# Lower Thames Crossing 9.144 Applicant's Response to Comments Made by Kent County Council at D5

**DATE: October 2023**  
**DEADLINE: 6**

Planning Inspectorate Scheme Ref: TR010032  
Examination Document Ref: TR010032/EXAM/9.144

# 9.144 Applicant’s Response to Comments Made by Kent County Council at D5

**Plate 2.1 Areas of consideration requested by KCC**

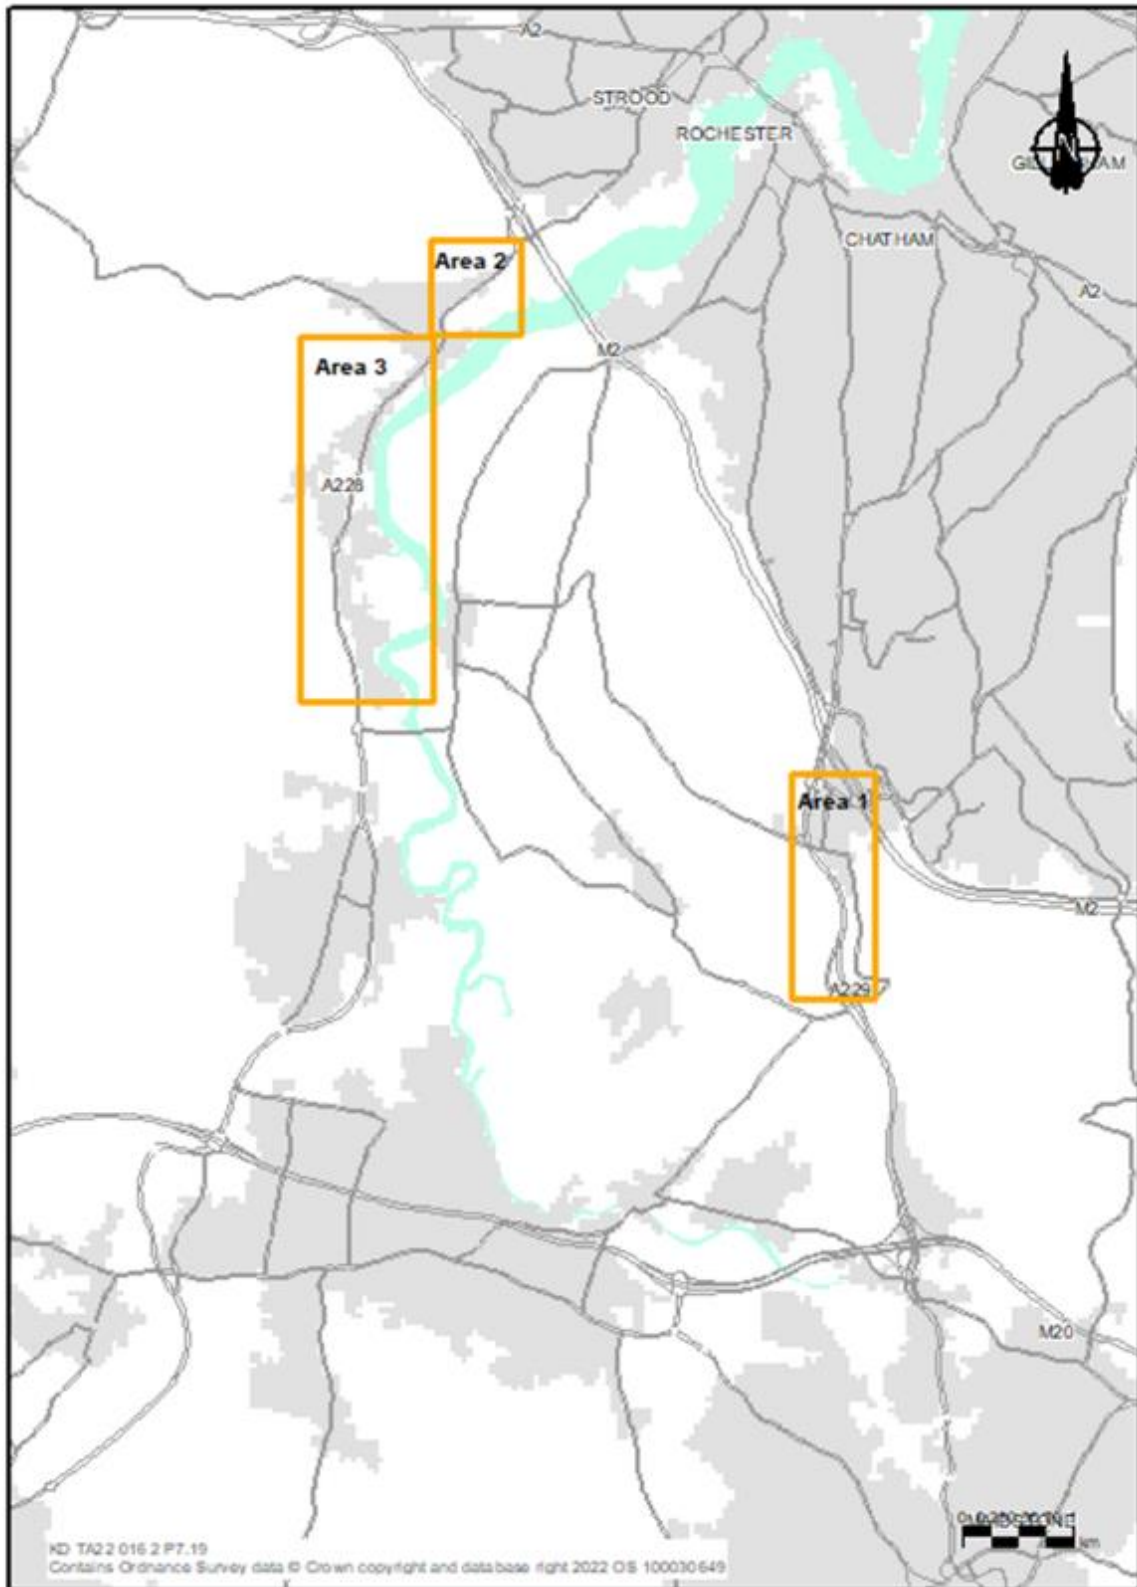
Page no.	KCC's comments	Applicant’s response
3	<p>In addition to the action points above, KCC’s Deadline 4 Submission [REP4-308] also provided comments on National Highway’s submissions at Deadline 3. KCC has since had an opportunity to review in detail the revised Transport Assessment documents, in particular the Deadline 3 submission 7.9 Transport Assessment (Part 1 of 3) [REP3-112] and sought clarity from the Applicant regarding the changes displayed in some of the graphics.</p> <p>The Applicant has provided KCC with additional detail regarding the changes made. Previously, some of the graphics incorrectly showed the volume to capacity information for the do-minimum scenario instead of the do-something scenario; and some had not applied a filter to only show the volume to capacity information where there was a change in flow of 50 trips or more.</p> <p>Whilst KCC accept the explanation provided, further clarification is required in respect to changes in the volume to capacity information for the A228 and A229. Both corridors are now presented with a significant reduction in congestion. However, KCC understands the flow changes on these corridors to exceed 50 trips, as such we are unclear on why the presented results substantially differ from The Applicant’s first submission of the Transport Assessment. This remains a Matter Under Discussion.</p>	<p>Further to KCC’s query in relation to the changes in the volume to capacity information for the A228 and A229 corridors (between the DCO application version of the Transport Assessment and that submitted at Deadline 3), the Applicant has checked and can confirm that the revised plates (which applied the +/- 50 Passenger Car Unit (PCU) filter) are correct.</p> <p>Plate 2.1 (beneath this table) shows three areas where links changed from coloured yellow/orange/red to grey as a result of the update to plates 7.19 – 7.24 inclusive (which present the volume to capacity for the AM, inter-peak and PM peak in the do-minimum and do-something scenarios for the Lower Thames area) in the Transport Assessment [REP4-148, REP4-150, REP4-152].</p> <p>In area 1, on the A229, in both the Do Minimum (DM) and Do Something (DS) scenarios in the AM peak the southbound link changed from red (95+%) to grey. This link is forecast to be at capacity in both scenarios in the AM peak. This means at this location that no increase in flow is forecast on the road. In the inter-peak and PM peak the link is not forecast to be at capacity, the increase in flows is above the 50 PCU threshold and the links are shown in the applicable colour to reflect the forecast v/c ratio.</p>

Page no.	KCC's comments	Applicant’s response
		<p>In areas 2 and 3, on the A228, there was no change to the mapping in the AM peak and inter-peak. In the PM peak in the DM and DS the southbound link has changed from yellow (75%&lt;85%) to grey and the northbound from red (95+%) to grey.</p> <p>This is because the links in the DM and DS PM peak are forecast to see an increase in flow of less than 50 PCUs.</p> <p>In summary the changes detailed above provide an overview as to how the presented results have changed from the first submission of the Transport Assessment to the Deadline 3 submission. The reasoning for these changes are unchanged from that already provided to KCC; to correctly display volume capacity for the do-something scenario rather than the do-minimum and adjust the filter to correctly account for the relevant volume capacity information.</p>
3	<p>Further to this, whilst KCC’s previous Deadline 4 <a href="#">[REP4-308]</a> position regarding main line traffic stands, in The Applicant’s Deadline 3 revised Transport Assessment <a href="#">[REP3-112]</a> Plate 7.3 for the PM peak 2045 now shows a significant increase in volume / capacity ratios along the A2 eastbound frontage road between the intersections of Gravesend East (A2 / Valley Drive) and the Three Crutches (A2 / M2 / A289). KCC would appreciate if The Applicant could provide additional information regarding vehicle speeds and flows on this corridor. This remains a Matter Under Discussion.</p>	<p>The Applicant has provided KCC with additional information on vehicle speeds and flows on the corridor, as requested.</p> <p>The Applicant will continue to engage with KCC relating to this matter if further discussion is required.</p>
